HISTORIC AND DESIGN REVIEW COMMISSION

April 05, 2023

HDRC CASE NO: 2023-106
ADDRESS: 501 E LOCUST
LEGAL DESCRIPTION: NCB 1736 BLK 10 LOT 1
ZONING: MF-33, H
CITY COUNCIL DIST.: 1
HIST. DIST. NAME: Tobin Hill Historic District
APPLICANT: Matthew Carson/Pella South Texas
OWNER: WOHLRABE SHANE & IRENE
TYPE OF WORK: Window replacement
APPLICATION RECEIVED: March 01, 2023
60-DAY REVIEW: Not applicable due to City Council Emergency Orders
CASE MANAGER: Jessica Anderson

The applicant requests a Certificate of Appropriateness for approval to replace 18 one-over-one wood windows with aluminum-clad wood windows.

Staff site visit
23 March 2023 9 AM

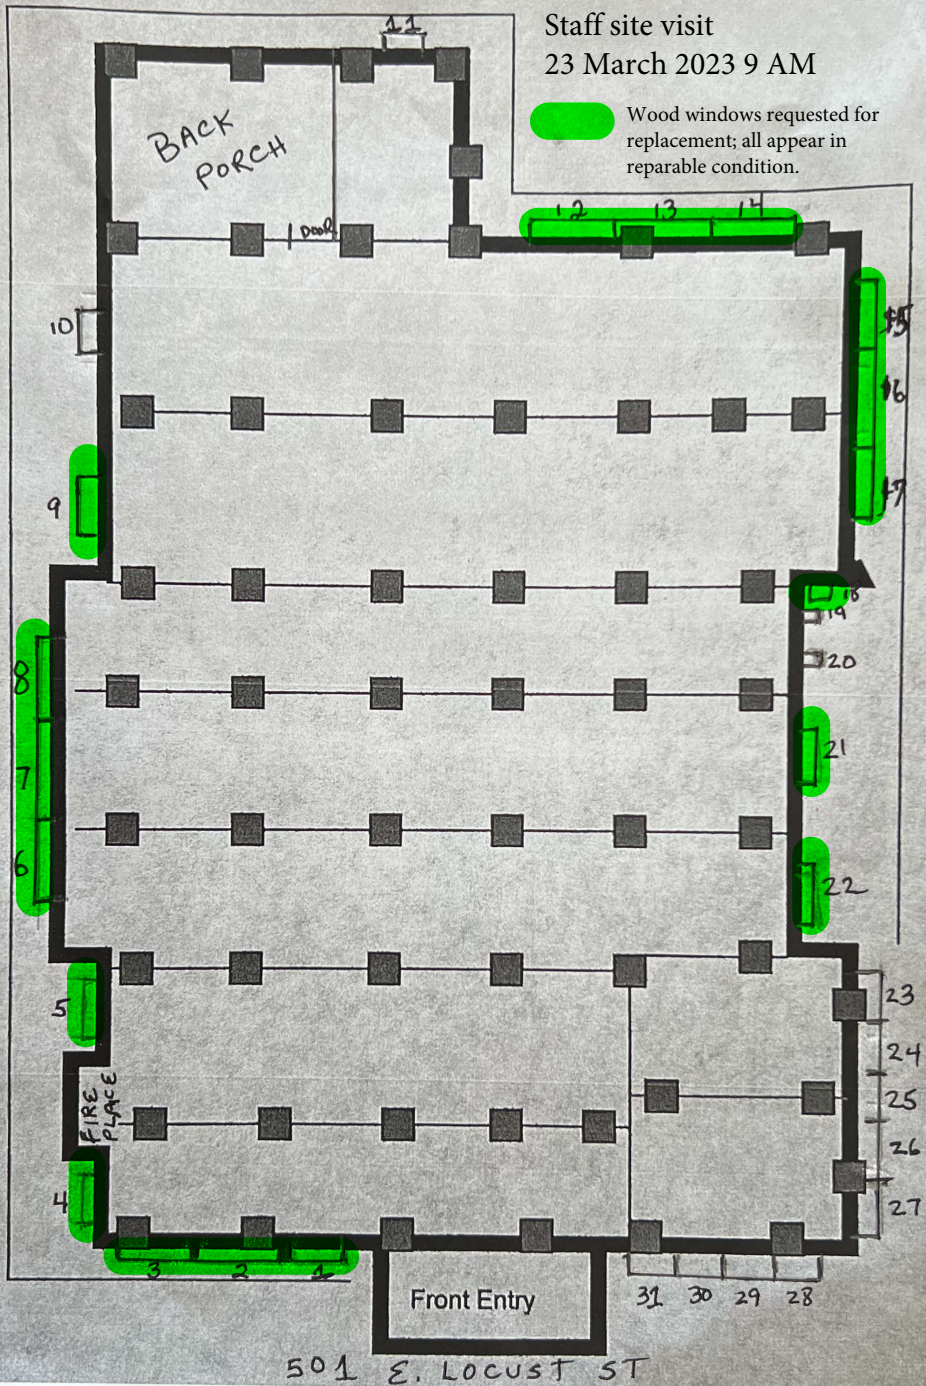
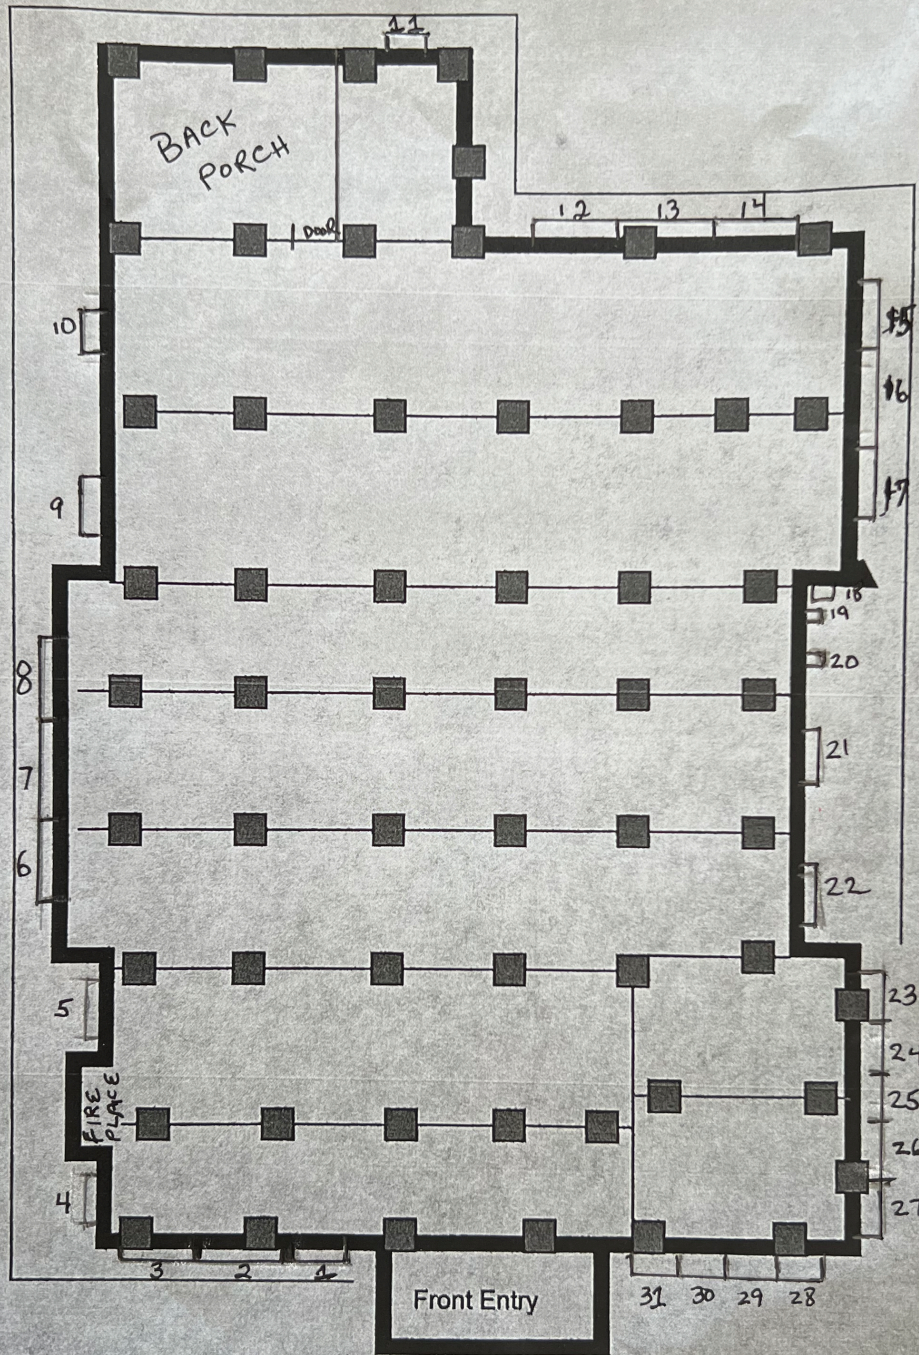
Wood windows requested for replacement; all appear in reparable condition.

Staff does not recommend approval based on findings c through f. Staff recommends that all existing wood windows are retained and repaired.
